## Field Safety Notice

FA 2021-010-002-LUL-001

**Subject:** Missing bushing on Liko M220 and M230 causing wear and potential for falls.

**Commercial name of affected product:** Liko M220, Liko M230

Figure 1: Mechanism and parts included in the sling bar for M220/M230. Bushing marked in red.

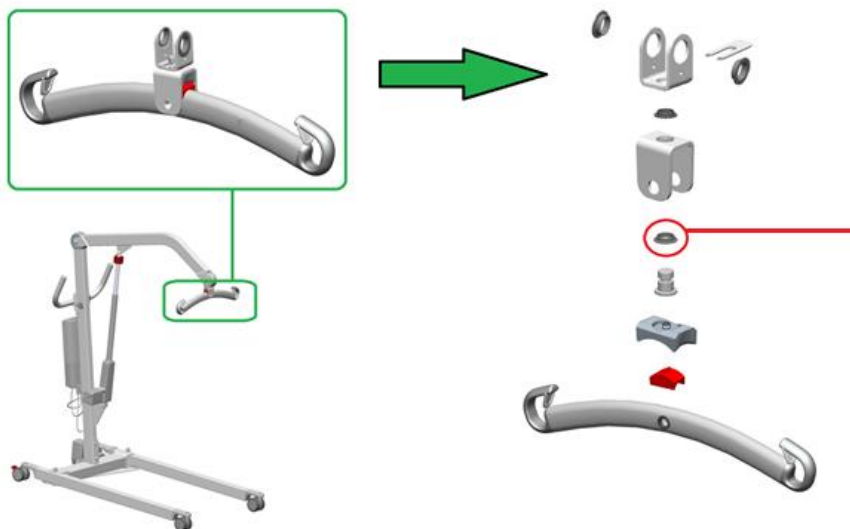
The sling bar on the Liko M220 and M230 mobile lift is locked into its position onto the lifting arm through two link plates, see figure 1. These two link plates are attached to each other through a bolt and a locking plate that allows for a rotation of the sling bar in one direction relative to the upper link plate.

Hillrom investigation determined that the root cause of the slingbar detachment is caused by wearing at the slingbar attachment due to the missing of a plastic bushing (see red markings in Figure 1) as part of the assembly during manufacturing of the device. It was determined that assembly of this device has the potential to not contain this plastic bushing on devices manufactured between 2016-DEC-27 and 2021-SEP-01.

Upon receipt of the response form, identifying potentially impacted devices, Hillrom or an official Hillrom distributor/representative will be in contact to schedule inspection of your device to confirm presence of the bushing. Where it is confirmed that the device is missing the bushing, a replacement slingbar with the bushing will be installed.

Figure 2: Placement of the label and its designs. Left: New design. Right: Old design.

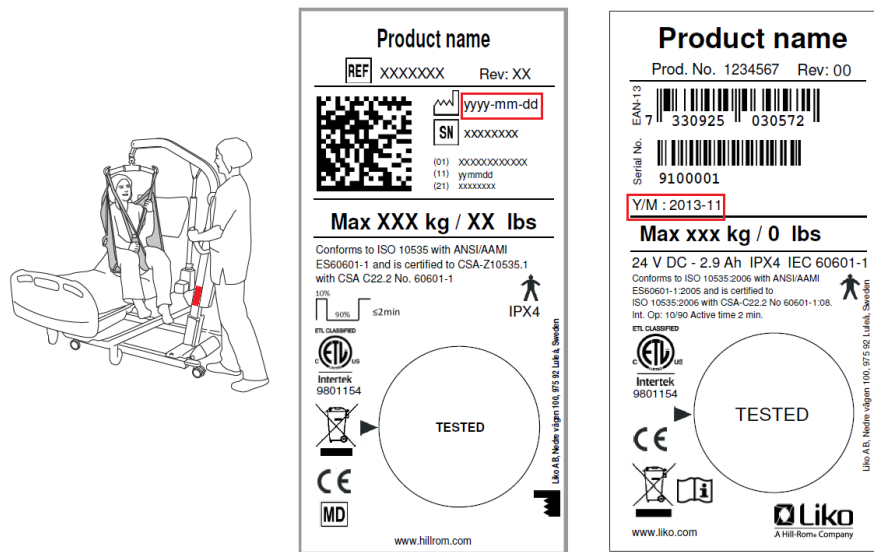
1. Review the product label on your Liko M220/M230 to determine if it is impacted by this field action by identifying the manufacturing date of the device (i.e. Manufacturing date between 2016-DEC-27 and 2021-SEP-01). See figure 2.
